Owner's Allowance Expenditure Authorization

PROJECT: (Name and address)
Webb County Justic Center
Building Envelope & Site Rehab Project
1110 Victoria St, Laredo, TX 78040

Contingency Allowance Authorization Number:
CA A - 004R
Date: October 15, 2025

Construction Change Directive

SHEET
A3.02
OF

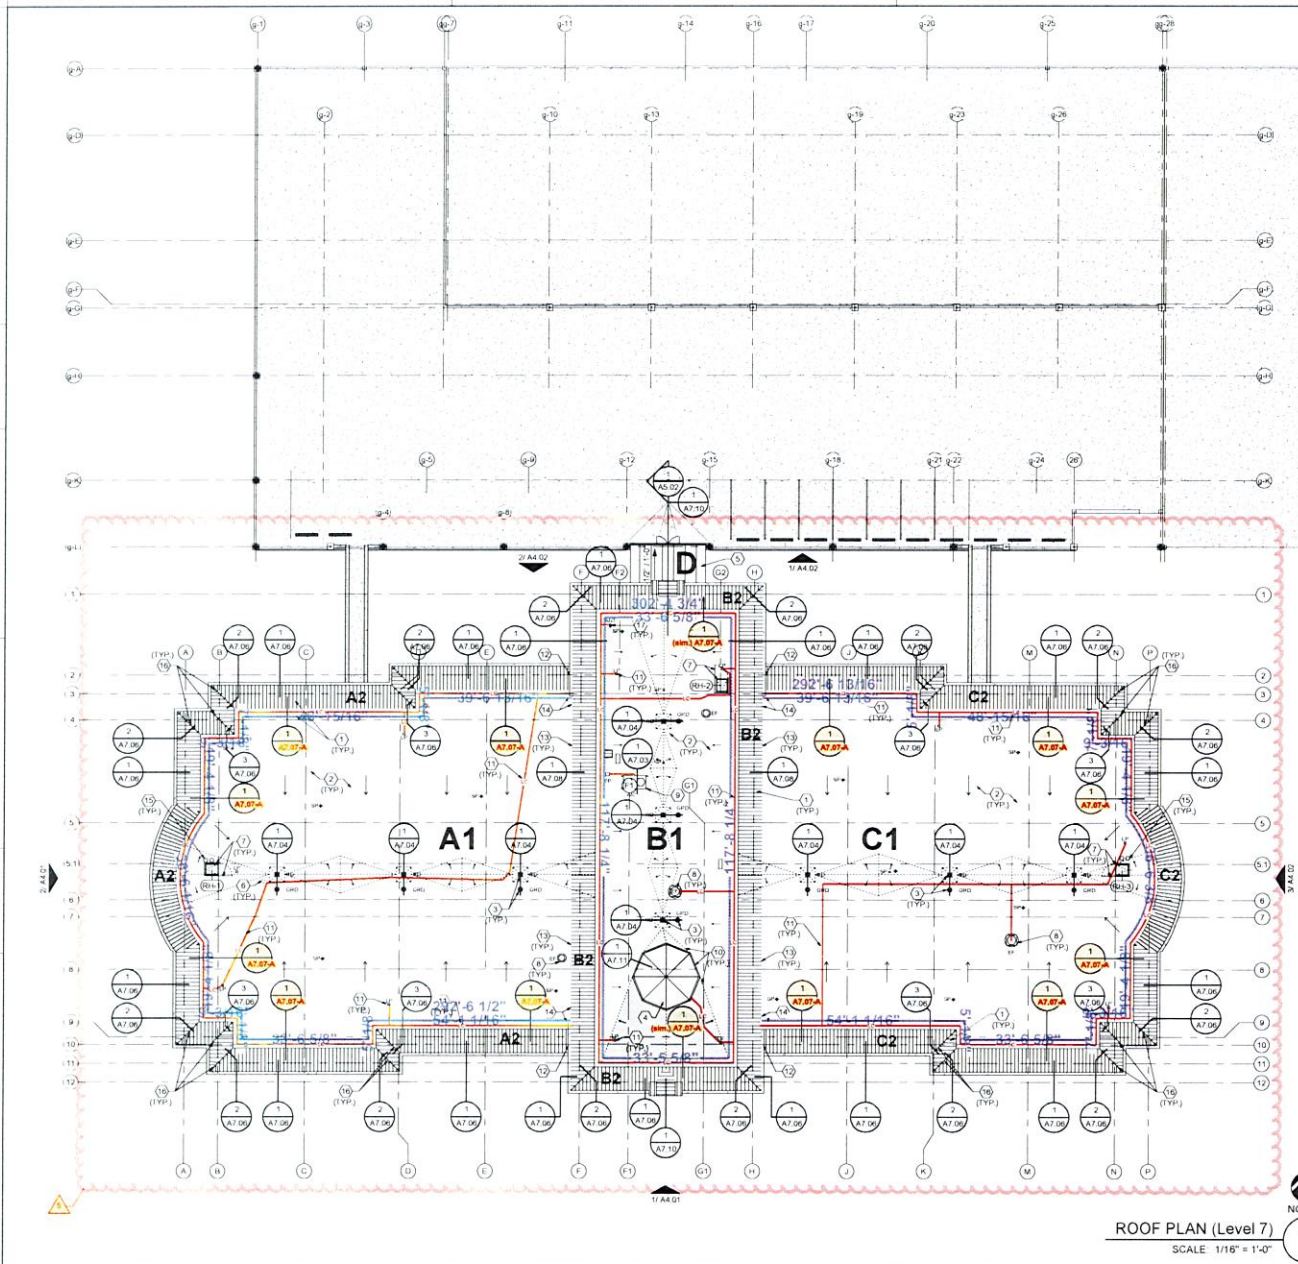
As identified in attached Drawings A3.02 and A7.07-A, reissued for CCD #02 on August 18, 2025, the Contractor shall evaluate all options presented and after analyzing the options for cost and schedule, shall provide the Architect and Owner a summary of the cost and time estimates for each option, from which the Owner and Architect will select and approve for execution. All parties understand that because the scope of this CCD involves unknown conditions and potentially volatile pricing caused by the current state of the markets, it will be impossible to identify the total cost for the work of any of these options identified in this CCD until it is completed. As time is of the essence, the Contractor shall commence work as soon as approval of the Option / Options by the Owner.

SHEET A7.07-A OF

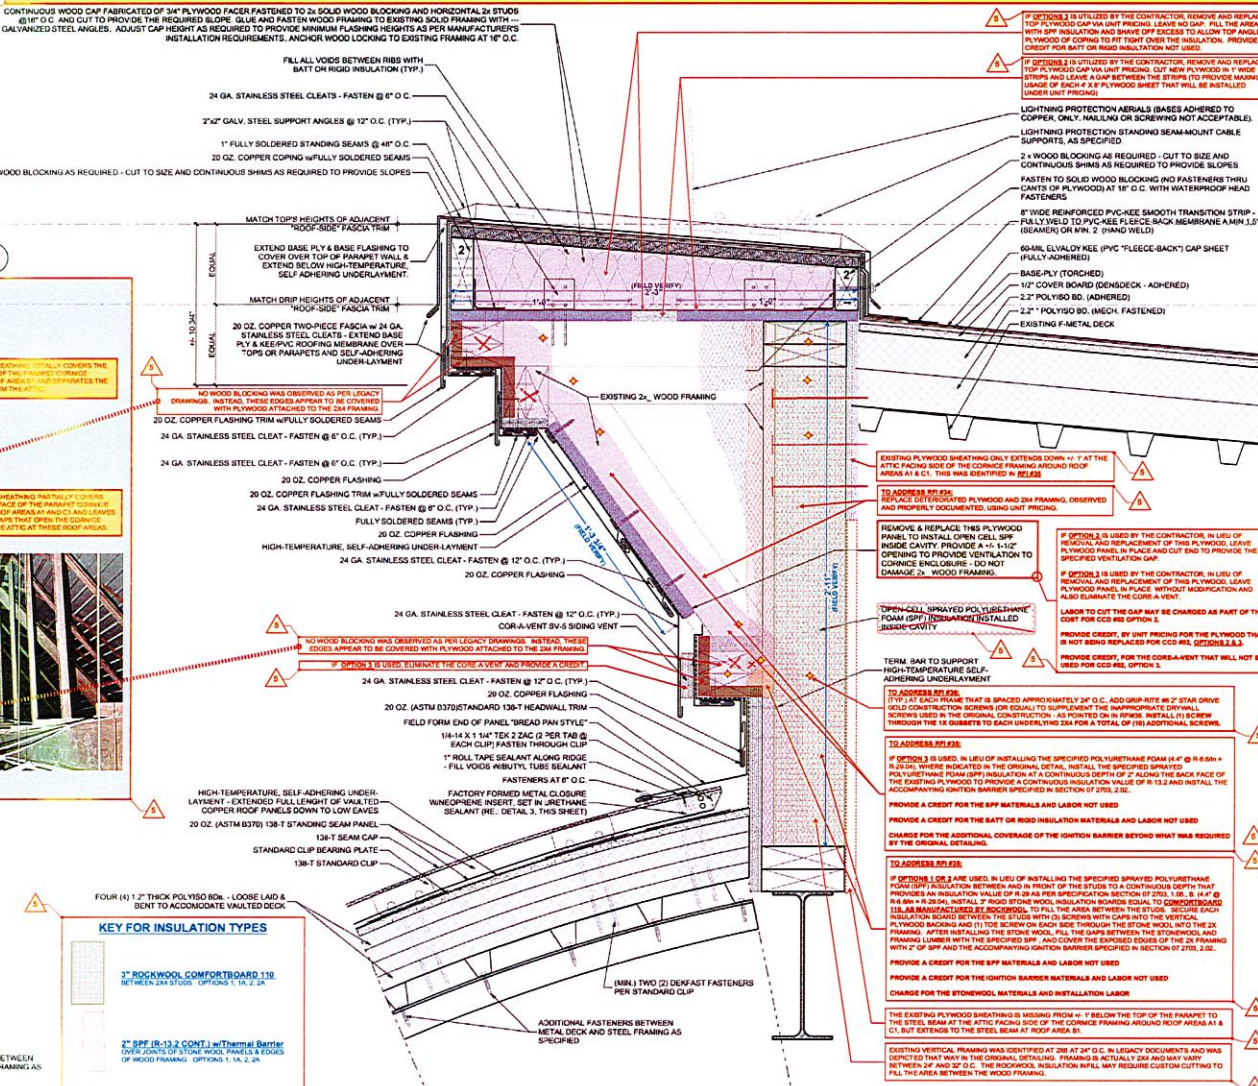
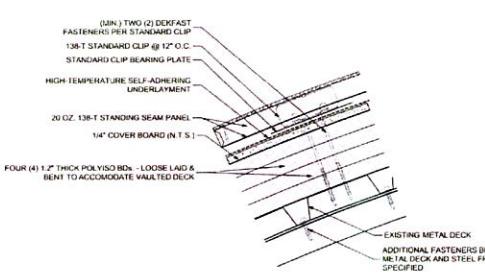
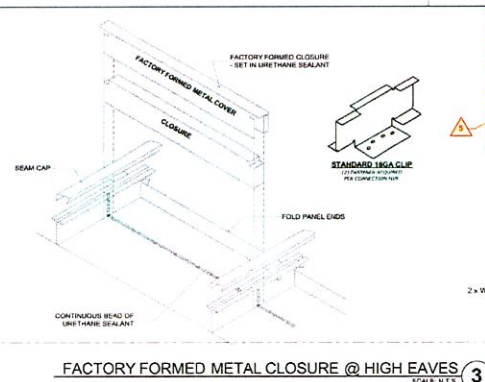
As per RFI #34, RFI#35 and RFI#36, the Contractor has identified possible deteriorated plywood and 2x wood framing, missing vertical plywood sheathing on the attic side of the cornice and the use of improper screws to secure the framing. Drawing sheet A7.07-A has been modified to Address RFI #34, RFI#35 and RFI#36 and to define the scope of work for Construction Change Directive #02 (CCD #02).

AT THE CONTRACTOR'S OPTION, IN ORDER TO INSTALL THE NEW INSULATION INSIDE THE CORNICE CONTRACTION, AND TO REPLACE ANY DETERIORATED PLYWOOD AND WOOD FRAMING MEMBERS AND TO ADD FASTENERS TO THE FRAMING TO SUPPLEMENT THE EXISTING DEFICIENT FASTENERS THE CONTRACTOR MAY EITHER:

OPTION 1 - WORK FROM MOBILE LIFTS AS ORIGINALLY PROPOSED TO REMOVE AND REPLACE THE PLYWOOD ON THE ANGLED VERTICAL FACE OF THE CORNICE AS CALLED OUT IN THE CURRENT CODE TO GAIN ACCESS FOR THE NECESSARY OBSERVATIONS AND REPAIRS IDENTIFIED IN CDD #32. UTILIZING A COMBINATION OF ROCKWOOL AND THE SFP INSULATION AND IGNITION BARRIER CURRENTLY IN THE CONTRACT, BEFORE INSTALLING THE NEW PARAPET CAP EXTENSION FILLED WITH BATT OR RIGID INSULATION. (OPTION 1A, ONLY AT ROOF AREA B1, SHOULD USE THE CURRENTLY SPECIFIED SFP INSULATION AND THERMAL BARRIER.)

OPTION 2 - WORK FROM ROOF LEVEL WITHOUT MOBILE LIFTS TO REMOVE AND REPLACE THE EXISTING PLYWOOD CAP AT THE CORNICE AS DETAILED BY CDD #32 VIA UNIT PRICING TO GAIN ACCESS FOR THE NECESSARY OBSERVATIONS AND REPAIRS IDENTIFIED IN CDD #32. UTILIZING A COMBINATION OF ROCKWOOL AND THE SFP INSULATION AND IGNITION BARRIER CURRENTLY IN THE CONTRACT, BEFORE INSTALLING THE NEW PARAPET CAP EXTENSION FILLED WITH BATT OR RIGID INSULATION. THIS OPTION WILL PROVIDE THE OWNER A CREDIT VIA UNIT PRICING FOR THE VERTICAL PLYWOOD THAT WILL NOT BE REPLACED AS A CONSEQUENCE, AND SHOULD PROVIDE THE CONTRACTOR THE OPPORTUNITY TO REDUCE THEIR LABOR AND ACCESS COSTS, WHICH DO NOT NEED TO BE CREDITED TO THE OWNER. (OPTION 2A, ONLY AT ROOF AREA B1, SHOULD USE THE CURRENTLY SPECIFIED SFP INSULATION AND THERMAL BARRIER.)

OPTION 3 - WORK FROM ROOF LEVEL WITHOUT MOBILE LIFTS TO REMOVE AND REPLACE THE EXISTING PLYWOOD CAP AT THE CORNICE AS DETAILED BY CDD #32 VIA UNIT PRICING TO GAIN ACCESS FOR THE NECESSARY OBSERVATIONS AND REPAIRS IDENTIFIED IN CDD #32. UTILIZING THE SFP INSULATION AND IGNITION BARRIER CURRENTLY IN THE CONTRACT, BEFORE INSTALLING THE NEW PARAPET CAP EXTENSION. THIS OPTION WILL PROVIDE THE OWNER A CREDIT FOR THE VERTICAL PLYWOOD AND CORNICE VENT THAT WILL NOT BE REPLACED AS A CONSEQUENCE, AND SHOULD PROVIDE THE CONTRACTOR THE OPPORTUNITY TO REDUCE THEIR LABOR AND ACCESS COSTS, WHICH DO NOT NEED TO BE CREDITED TO THE OWNER. (OPTION 3 IS NOT VAILABLE FOR ROOF AREA B1, BECAUSE IT WOULD CREATE A CORNICE VENT THAT IS NOT VENTILATED.)

1. For the replacement of existing plywood (addition), and the elimination of contracted scope that involves the replacement of existing plywood (deduction), for all options, use the unit pricing schedule in the contract.
2. For the replacement of existing deteriorated plywood and lumber, for all options, that are not otherwise scheduled to be replaced that are related to RFI #34, that has been properly catalogued to identify the deterioration, type, size, length and/or area, use the unit pricing schedule in the contract.

3. For the addition of screws to supplement the currently deficient screw installation identified in RFI # 36, for all options, provide the cost to procure and install these screws plus any allowances for overhead and profit that may be applicable in accordance with the construction contract.

4. For the addition of rigid stone wool insulation to accommodate the missing plywood identified in RFI # 35, for Options 1, 1A, 2, and 2A, provide the cost to procure and install these insulation boards plus any allowances for overhead and profit that may be applicable in accordance with the construction contract.

5. For the addition of the scope for the ignition barrier identified in Specification Section 07 2703, for Option 3, provide the cost to procure and install the additional materials plus any allowances for overhead and profit that may be applicable in accordance with the construction contract.

6. For the reduction of scope for the Sprayed Polyurethane foam insulation identified in Specification Section 07 2703, for Options 1, 1A, 2, 2A and 3, credit the Owner for all materials not used, plus the labor not used commensurate to the reduction in materials, plus the commensurate reduction in overhead and profit related to the reduction of the installed scope.

7. For the reduction of scope for the ignition barrier identified in Specification Section 07 2703, for Options 1, 1A, 2, and 2A, credit the Owner for all materials not used, plus the labor not used, commensurate to the reduction in materials, plus the commensurate reduction in overhead and profit related to the reduction of the installed scope.

8. For the deletion of the Core-A-Vent SV-5 Siding vent materials for Option 3, credit the Owner for all materials not used, plus the labor not used, commensurate to the reduction in materials, plus the commensurate reduction in overhead and profit related to the reduction of the installed scope.

9. For the deletion of the batt or rigid insulation materials at the coping framing for Option 3, credit the Owner for all materials not used, plus the labor not used, commensurate to the reduction in materials, plus the commensurate reduction in overhead and profit related to the reduction of the installed scope.
